# Access Compliance Report

## Public Rights-of-Way

### (Curb Ramps)

Intersection ID: 10036443	Main Street: ROYAL_CASTLE_CT	Cross Street: N/A	Location: NW
ADA ID: 8B16B6A11F96	Ramp Type: BlendTrans1	Initial Pass/Fail: Fail	Overall Compliance: No
Codes/Mitigation Info/Possible Solution		Field Measurements/Component Compliance	
Severity Score: 10

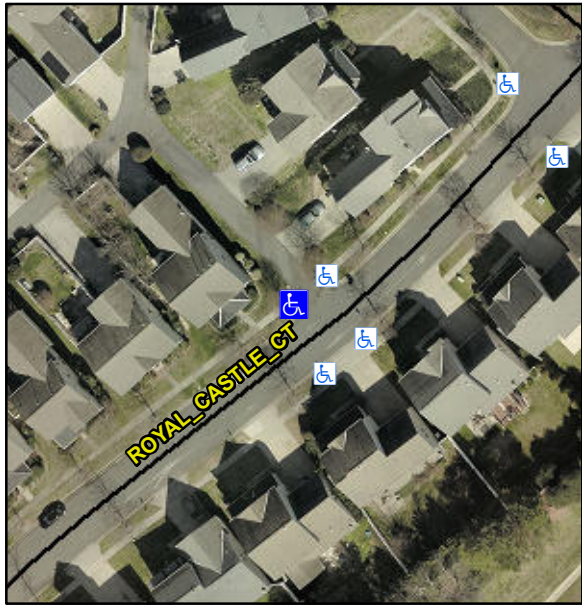
Compliance	Description	Data	Compliance	Description	Data
N/A	Ramp Length (in)	87.0	Yes	BlendTrans Slope (%)	3.2
No	Ramp Width (in)	41.0	Yes	BlendTrans XSlope (%)	2.5
N/A	Flare Type LT	N/A	N/A	Flare Type RT	N/A
N/A	Flare Slope LT (%)	N/A	N/A	Flare Slope RT (%)	N/A
N/A	Flare Traversable LT?	N/A	N/A	Flare Traversable RT?	N/A
N/A	Landing Length (in)	N/A	N/A	DWS Provided?	N/A
N/A	Landing Width (in)	N/A	N/A	DWS Contrast?	N/A
N/A	Landing Slope (%)	N/A	N/A	DWS Length (in)	N/A
N/A	Landing X Slope (%)	N/A	N/A	DWS Full Width?	N/A
N/A	Landing Curb? (Y/N)	N/A	N/A	DWS Offset (in)	N/A
N/A	Shared Landing?	N/A			
N/A	Gutter Ponding?	N/A	N/A	Gutter Slope (%)	N/A
N/A	Gutter Lip Ht (in)	N/A	N/A	Gutter X Slope (%)	N/A
N/A	Painted X Walk1?	No	N/A	Painted X Walk2?	No
	X Walk 1 Direction	To SE		X Walk 2 Direction	To NE
	X Walk 1 Width (in)	N/A		X Walk 2 Width (in)	N/A
	X Walk 1 Slope (%)	4.3		X Walk 2 Slope (%)	4.9
	X Walk 1 X Slope (%)	5.8		X Walk 2 X Slope (%)	1.6

N/A	Ramp inside XWalk1?	N/A	N/A	Ramp inside XWalk2?	N/A
	Road Slope (%)	4.4		Clear Space?	N/A
	Road X Slope (%)	4.7	N/A	Clear Space to XWalk (in)	N/A
N/A	Any Obstructions?	N/A	N/A	Storm Grate/Utility Hazard?	N/A
	Obstruction Type			Storm Grate/Utility Type	
		N/A			N/A
			Yes	Surface Condition? (G/P)	Good
			N/A	Curb Slope (%)	0.3

Possible Solutions:				
	Remove & Replace Curb Ramp With Two New Directional Ramps or Equivalent.				
	Surveyor Notes:				
	N/A				
	PROW/ADA:				
	R304.5.1				
	Street 1 Name		ROYAL CASTLE CT		
	Stop Condition-Street 1		None		
	Street 2 Name		N/A		
	Stop Condition-Street 2		None		
Total Cost:		\$	3200.00
